PENRITH CITY COUNCIL

MAJOR ASSESSMENT REPORT

Application number:	DA19/0713
Proposed development:	Demolition of Existing Structures and Construction of a Seven (7) Storey Mixed Use Development Including Ground and First Floor Commercial Tenancies, 41 Residential Apartments & Three (3) Levels of Basement Car Parking
Property address:	40 Orth Street, KINGSWOOD NSW 2747 38 Orth Street, KINGSWOOD NSW 2747 26 Somerset Street, KINGSWOOD NSW 2747
Property description:	Lot 61 DP 36728 Lot 60 DP 36728 Lot 62 DP 36728
Date received:	17 October 2019
Assessing officer	Paul Anzellotti
Zoning:	Zone B4 Mixed Use - LEP 2010
Class of building:	Class 2 , Class 7a , Class 6
Recommendations:	Refuse

DA30

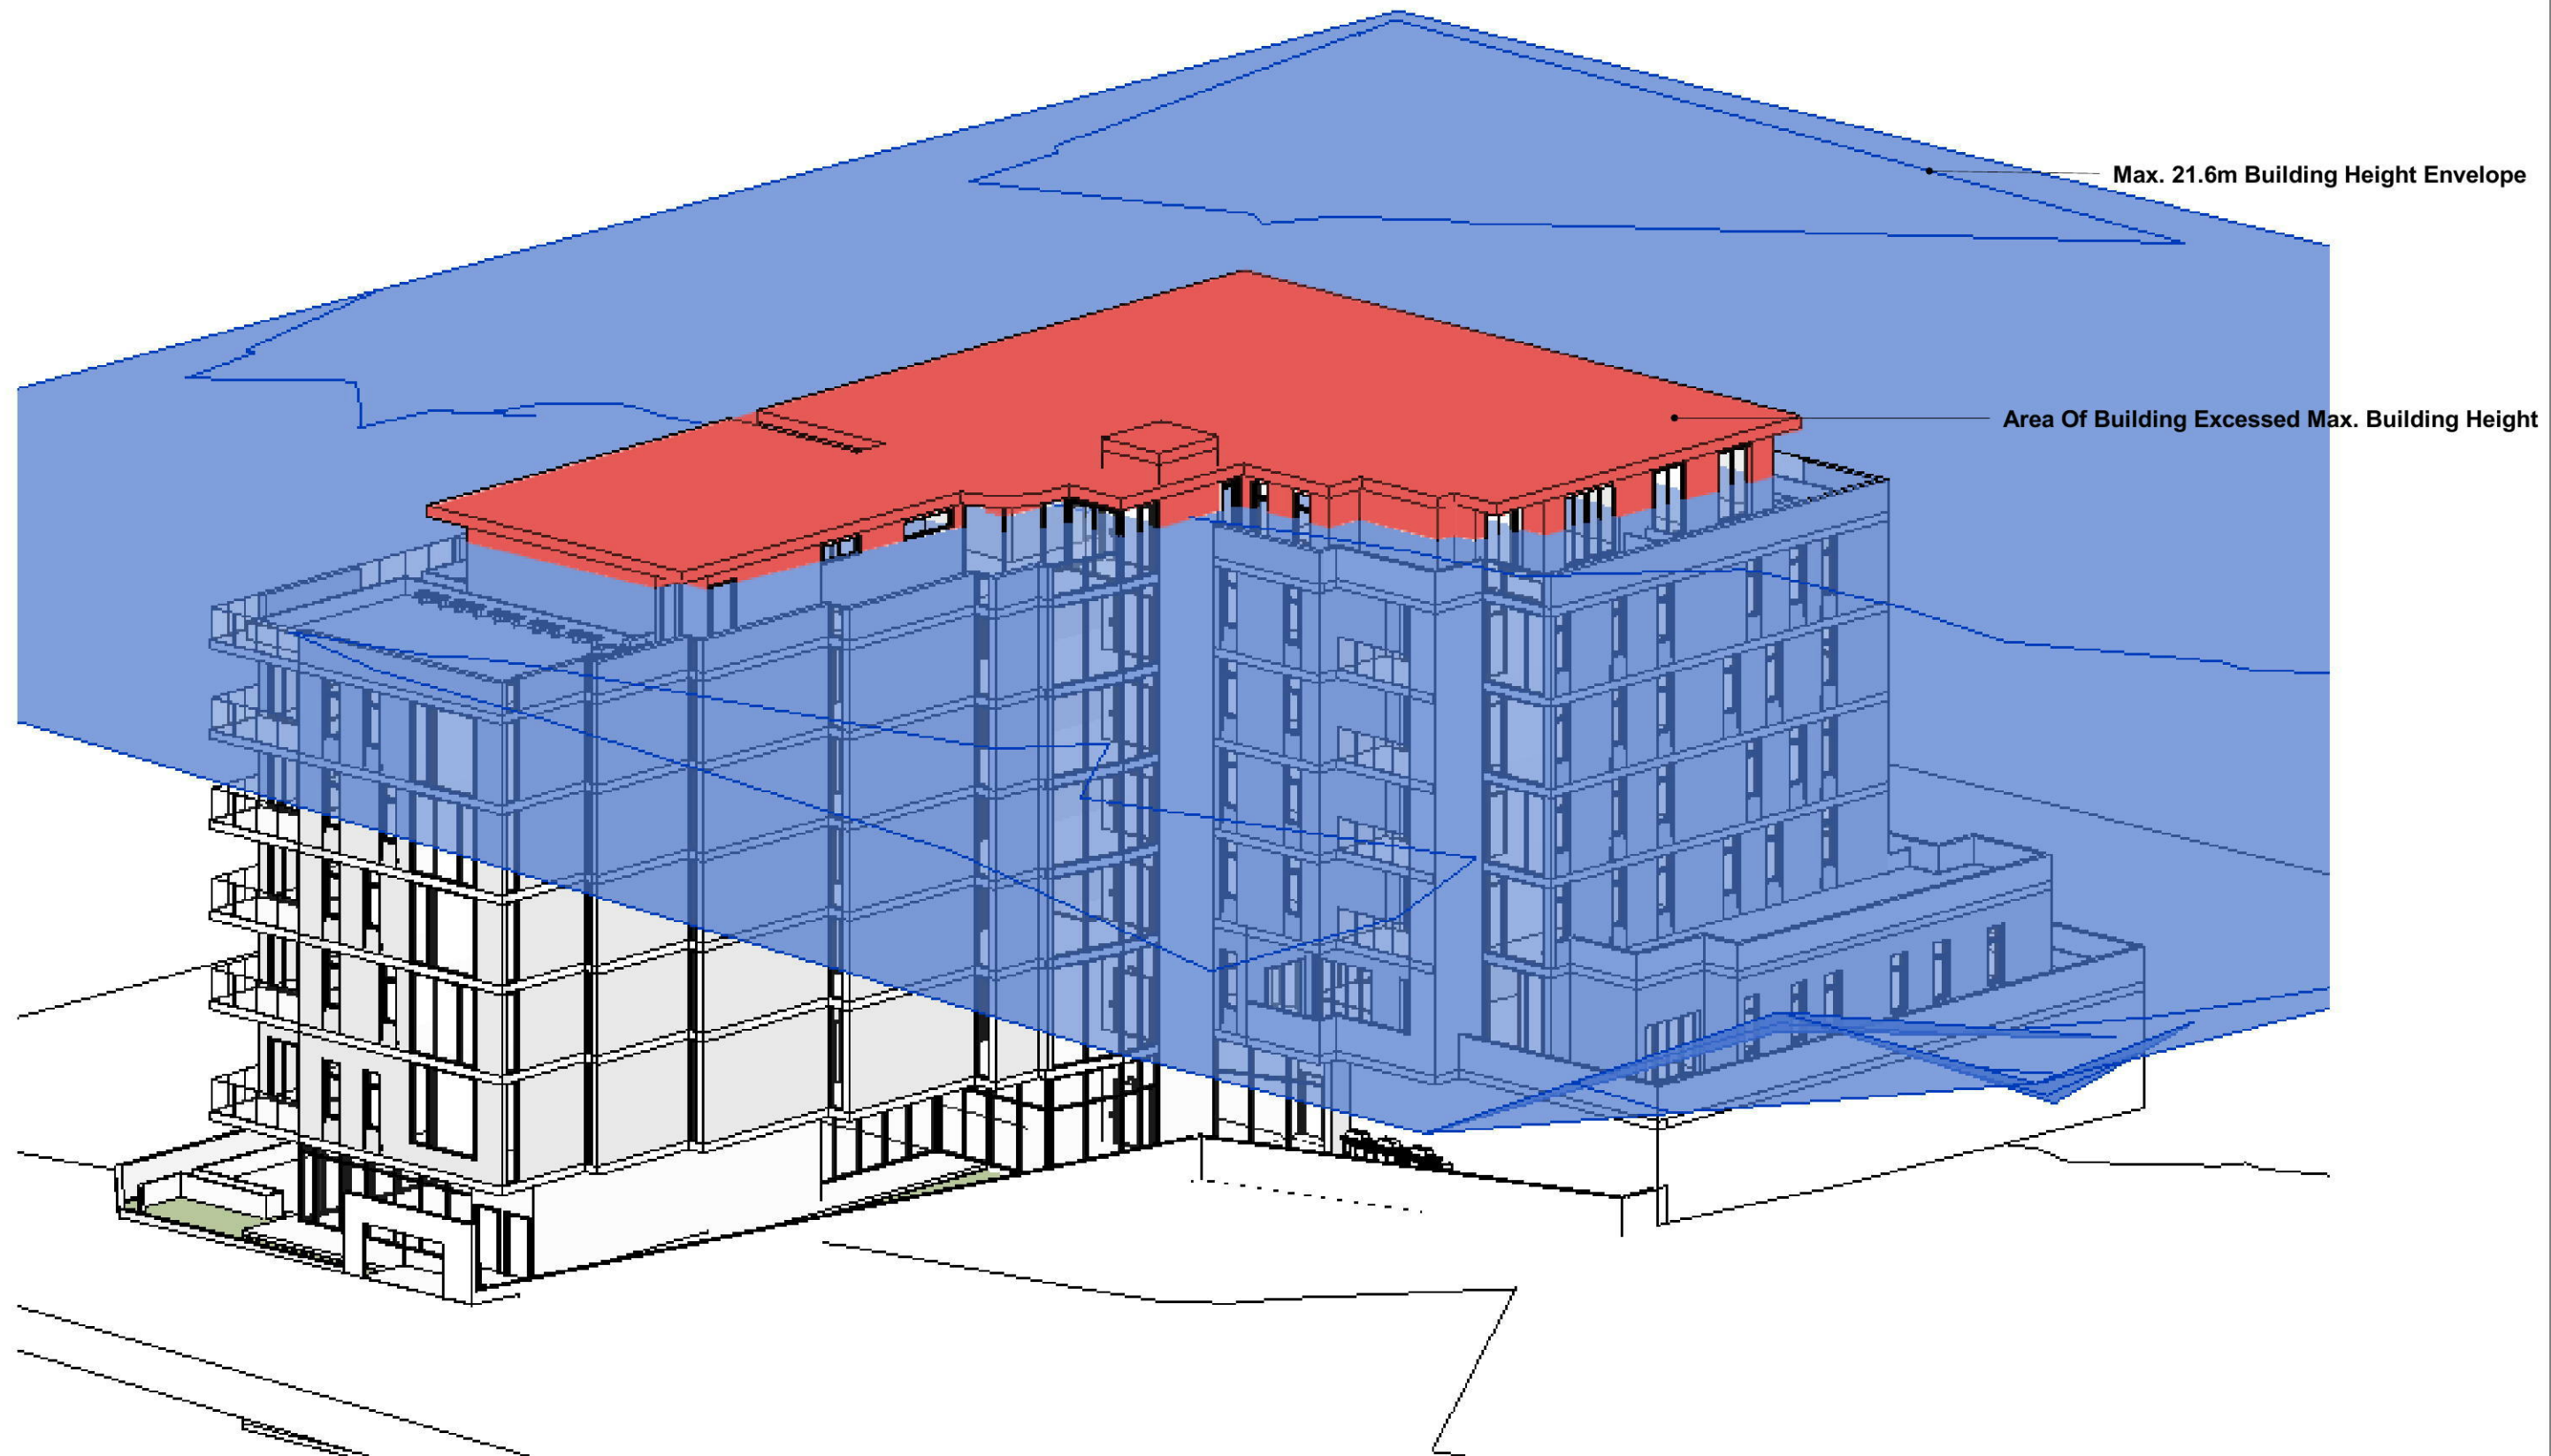
An assessment of the accompanying architectural plans has identified that the proposal is provided with an overall non compliant height of 22.7m to the top of the roof (overall height non compliance of 1.1m or 5% above the maximum height permitted) and a non compliance to the lift overrun of 23.7m (overall height non compliance of 2.1m or 9.7% above the maximum height permitted).

Figure 1 – 3D Height Plane Representation of Height Encroachment

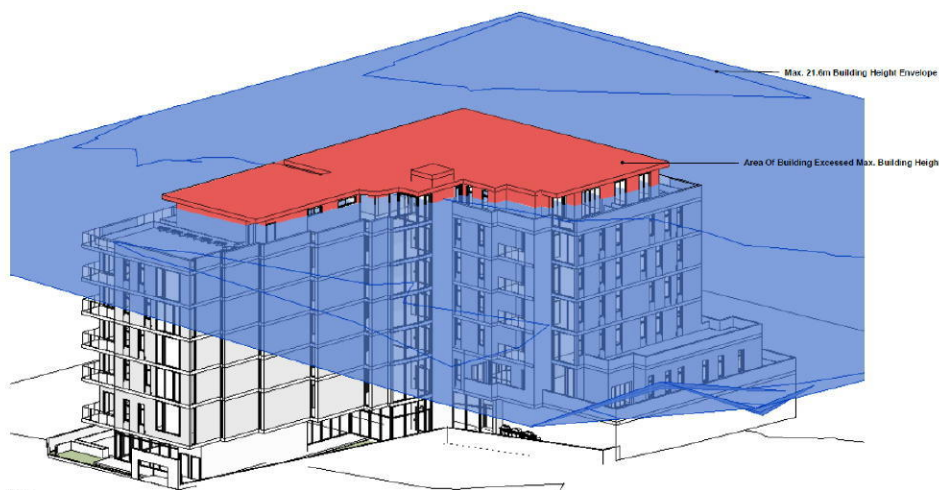
As demonstrated in the 3D drawing at **Figure 1**, the limited portion of the building extending above the 21.6m maximum building height control contributes minimally to the overall height, bulk and scale of the building.
